# Access Compliance Report

## Public Rights-of-Way

### (Curb Ramps)

Intersection ID: 30454	Main Street: SHALOM_PARK_DR	Cross Street: PROVIDENCE_RD	Location: NE
ADA ID: BC58698A79EB	Ramp Type: Directional1	Initial Pass/Fail: Fail	Overall Compliance: No
		Severity Score: 12.5

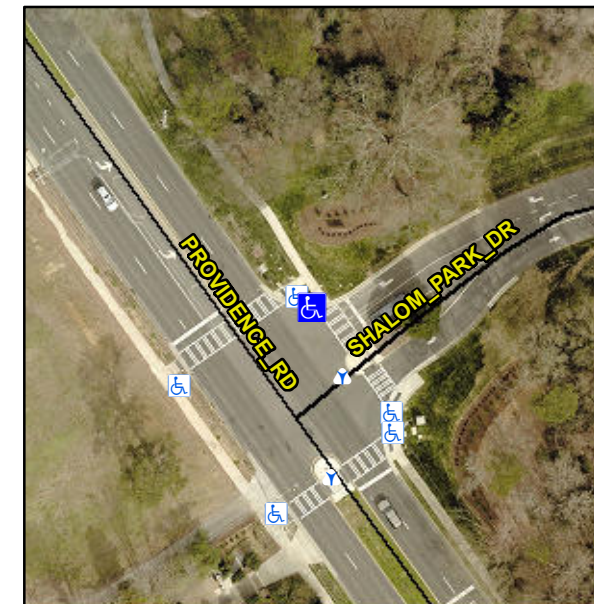
**Remove & Replace Entire Ramp.**

**R304.2.2**

Compliance	Description	Data	Compliance	Description	Data
N/A	Ramp Length (in)	153.0	N/A	Grade Break?	N/A
Yes	Ramp Width (in)	57.0	N/A	Grade Break Slope (%)	0.0
No	Ramp Slope (%)	8.7	N/A	Grade Break XSlope (%)	0.0
Yes	Ramp XSlope (%)	1.9			
N/A	Flare Type LT	N/A	N/A	Flare Type RT	N/A
N/A	Flare Slope LT (%)	N/A	N/A	Flare Slope RT (%)	0.0
N/A	Flare Traversable LT?	N/A	N/A	Flare Traversable RT?	N/A
N/A	Landing Length (in)	0.0	N/A	DWS Provided?	N/A
N/A	Landing Width (in)	0.0	N/A	DWS Contrast?	N/A
N/A	Landing Slope (%)	0.0	N/A	DWS Length (in)	N/A
N/A	Landing X Slope (%)	0.0	N/A	DWS Full Width?	N/A
N/A	Landing Curb? (Y/N)	N/A	N/A	DWS Offset LT (in)	N/A
N/A	Shared Landing?	N/A	N/A	DWS Offset RT (in)	N/A
N/A	Gutter Ponding?	0.0	N/A	Gutter Slope (%)	N/A
N/A	Gutter Lip Ht (in)	0.0	N/A	Gutter X Slope (%)	N/A
N/A	Painted X Walk1?	Yes		Road Slope (%)	2.0
	X Walk 1 Direction	To SE		Road X Slope (%)	3.5
	X Walk 1 Width (in)	110.0		Clear Space?	N/A
